MEMORANDUM

From:	Tina Cuss Ecology Officer		
Service	WBC Ecology	App No:	252145
Address:	Castlemans Cottage, Bath Road, Hare Hatch, Wokingham, RG10 9UT.		
Proposal:	Application for submission of details to comply with the following conditions of Listed Building consent 251022 dated 17/07/2025. Condition 3 relates to submission of a bat closing-out report and condition 4 to an updated Method Statement.		
Type of Development:			
Site Visit Made:	No

Figure 7 - Dimensions of Flashing Gap

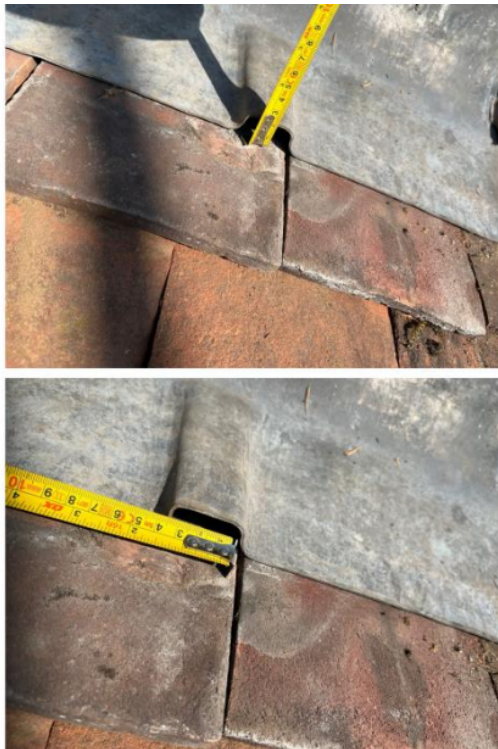
I am not fully satisfied by the photos in the Bat Close-Out Report that the works have been carried out in full accordance with PRA Section 4.2.2. It is not clear if some of

the dimensions of the access gaps created are smaller than specified in Section 4.2.2. No alternative ecologist-approved method statement has been provided to the LPA. I also note that no information is provided on the timbers or timber treatments which have been used in construction.

I welcome the inclusion of the additional boxes in the rear garden which I am satisfied have been appropriately installed. I will be happy to recommend discharge of the condition once evidence is provided of ecological supervision and that project ecologist has either authored, or has provided written or email confirmation they are fully satisfied with Closing-out Report.
